Access Compliance Report

Public Rights-of-Way

Intersection ID: N/A	Main Street: CLANTON_RD	Cross Street: I-77_TO_CLANTON_RD	Location: NW
ADA ID: D83F02D73E20	Ramp Type: Perp	Initial Pass/Fail: Pass	Overall Compliance: No
		Severity Score: 5

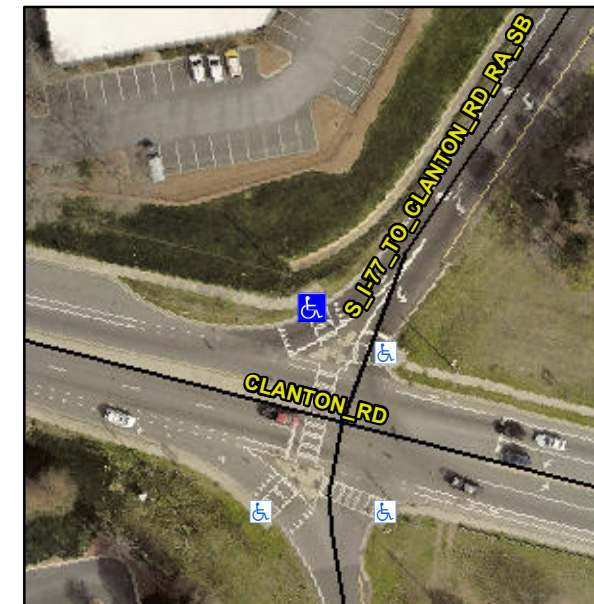
**R304.2.2-Perp, R304.3.2-Para,
R305.2, R304.5.4**

**Remove & Replace Entire Ramp.
Remove & Replace Gutter.**
